Safety Recall

Code: 42E7

Subject Rear Tie Rod Bolt

Section B – Rear Tie Rod Bolt Inspection

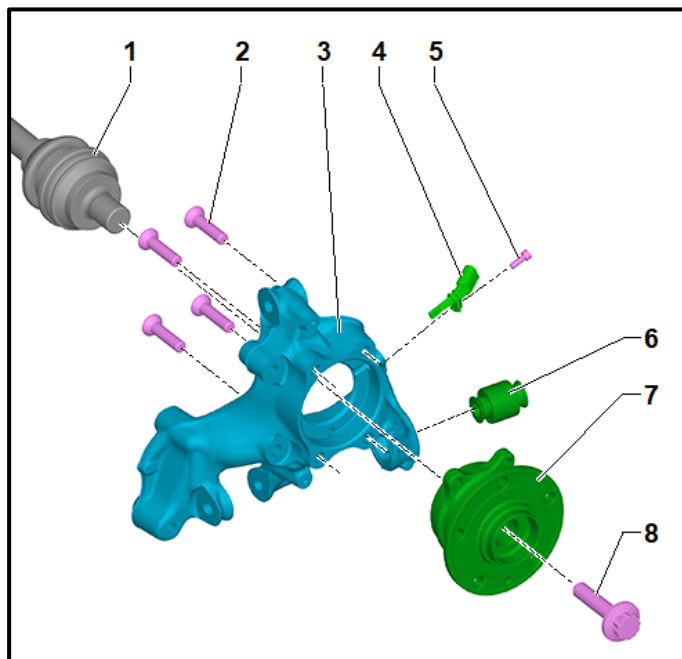
- Remove the rear wheel.
- Remove the tie rod bolt <1>.
- Inspect the bolt <1> for any signs of damage such as:
 - Cracks in the bolt.
 - The bolt is broken.
 - The bolt head has broken off.
 - Damaged threads.
- If the bolt <1> is damaged:
 - Proceed to Section C.
- If the bolt <1> is not damaged:
 - Replace the bolt <1>.
 - Torque to 70 Nm + 180°.
- Reassemble the vehicle in the reverse order of removal.

Ensure that the rear suspension is in the curb weight position when tightening the bolt.

An axle alignment is not required after replacement of the bolt.

Section C – Replace Rear Suspension Components

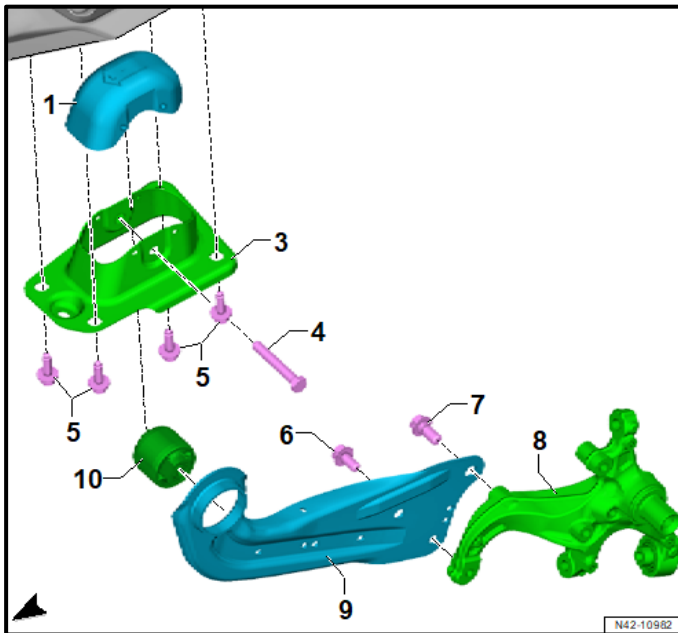
- Replace the wheel bearing housing <3> per the ELSA repair manual:
 - *Repair manual > Chassis > Suspension, Wheels, Steering > 42 Rear Suspension > Wheel Bearing and Trailing Arm, Multi-Link Suspension.*
- When replacing the wheel bearing housing, also replace the following components per the ELSA repair manual:
 - Wheel bearing / hub assembly <7>.
 - Wheel speed sensor <4>.
 - Brake dust shield / backing plate (not pictured).
 - All associated nuts and bolts.

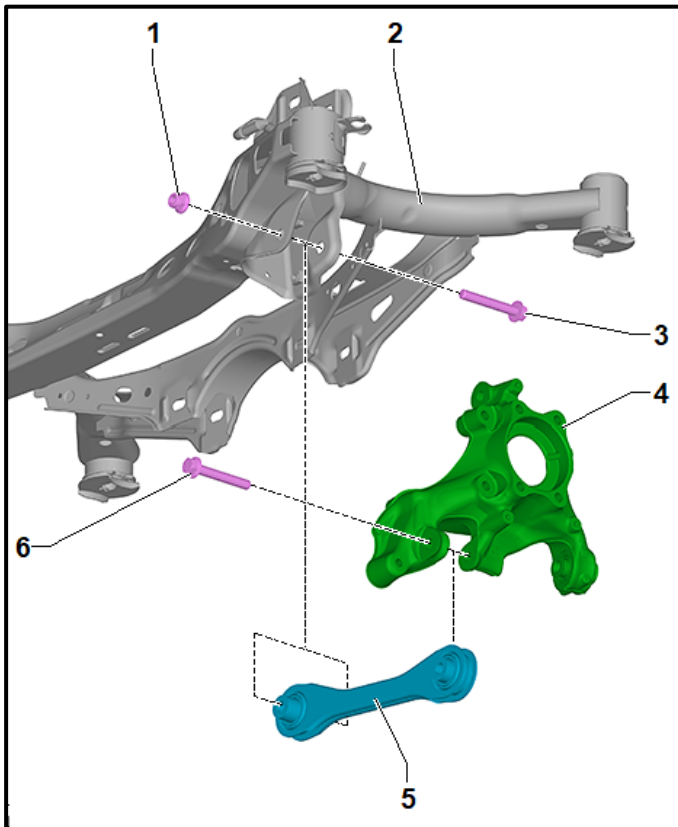
- Replace the trailing arm assembly <9>, trailing arm bracket <3>, and trailing arm bracket cover <1> per the ELSA repair manual:
 - *Repair manual > Chassis > Suspension, Wheels, Steering > 42 Rear Suspension > Wheel Bearing and Trailing Arm, Multi-Link Suspension.*
- Replace all associated nuts and bolts.

- Replace the rear tie rod <5> per the ELSA repair manual:
 - *Repair manual > Chassis > Suspension, Wheels, Steering > 42 Rear Suspension > Control Arm, Tie Rod.*
- Reassemble the vehicle in the reverse order of removal, ensuring that all single use fasteners are replaced.
- Perform a 4-wheel alignment per the ELSA repair manual.
- Depending on vehicle equipment:
 - Calibrate the driver assist systems per the ELSA repair manual.
